# Program Bulletin

## CUSTOMER SATISFACTION PROGRAM

**SUBJECT:** Front Strut Noise Phase II

**MODELS:** 2013 Chevrolet Trailblazer

Figure 1

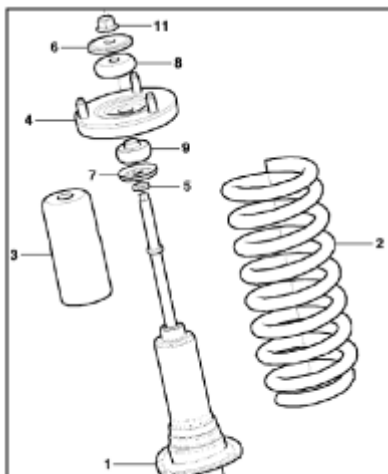
4. Before removing the top mount bracket (refer figure 1, item 4), place alignment marks on the top mount bracket and spring using the outboard mounting bolt on the strut top bracket as a reference. Mark the bottom of the spring to shock absorber as well. These marks should all be aligned as shown in figure 2 and 3.

6. Refer to figure 1 - the lower bush (9) will be replaced as well as the spring seat insulator (not shown in figure 1). In addition, inspect the top mount bracket (4), cup washer (7), upper bush (8), and shocker absorber rod (1) for damage. Follow these guidelines to determine if these parts should be replaced:

Figure 6

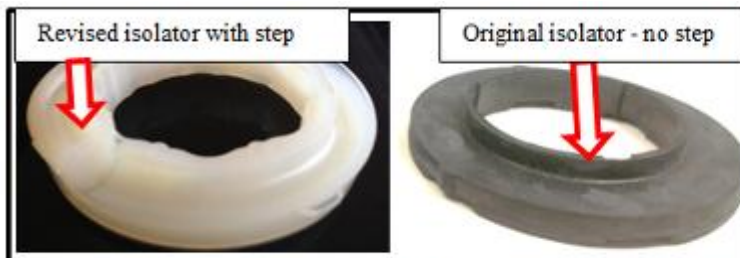
7. Install the revised spring seat insulator (52057793) to the top of the spring. The revised insulator has a step or recess in it for the end spring coil to sit in. Ensure the spring sits fully into the step/recess, refer figure 6 & 7.
